U.S. CONSUMER PRODUCT SAFETY COMMISSION 4330 EAST WEST HIGHWAY BETHESDA, MD 20814

On January 11, 2011, the U.S. Consumer Product Safety Commission (CPSC) staff received the second canvass draft of ANSI/OPEI B71.9-20XX, *American National Standard for Multipurpose Off-Highway Utility Vehicles*. ¹ CPSC staff reviewed the draft and believes that the proposed standard does not adequately address vehicle stability, vehicle handling, and occupant protection performance.

Figure 2. Steering diagram of unmodified vehicle and modified vehicle in clockwise (CW) and counterclockwise (CCW) directions.

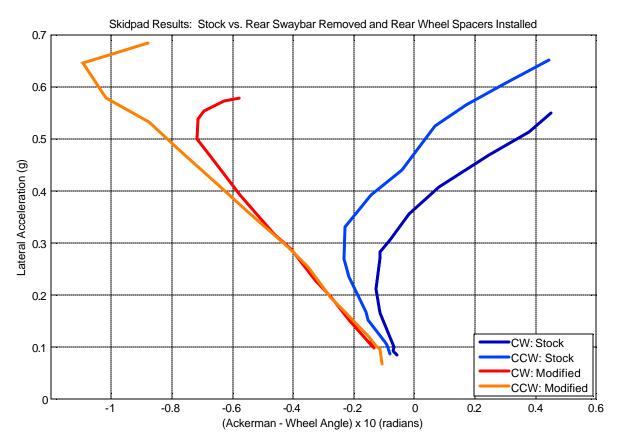
CPSC staff continues to believe that steady state oversteer is an undesirable and unstable steering control mode for vehicles. Therefore, staff believes that a test to measure steering gradient and an acceptance criterion for handling characteristics is necessary. CPSC staff's experience with vehicle dynamic testing has shown that altering the steering characteristics of a vehicle is not difficult. Staff successfully altered the steering characteristics of a vehicle that originally exhibited steady state oversteer by adding spacers to the rear wheels and removing the rear sway bar (see Figure 1).

The effectiveness of the modifications in improving the vehicle from oversteer (blue lines) to understeer (red and orange lines) is illustrated in the vehicle diagram shown in Figure 2.
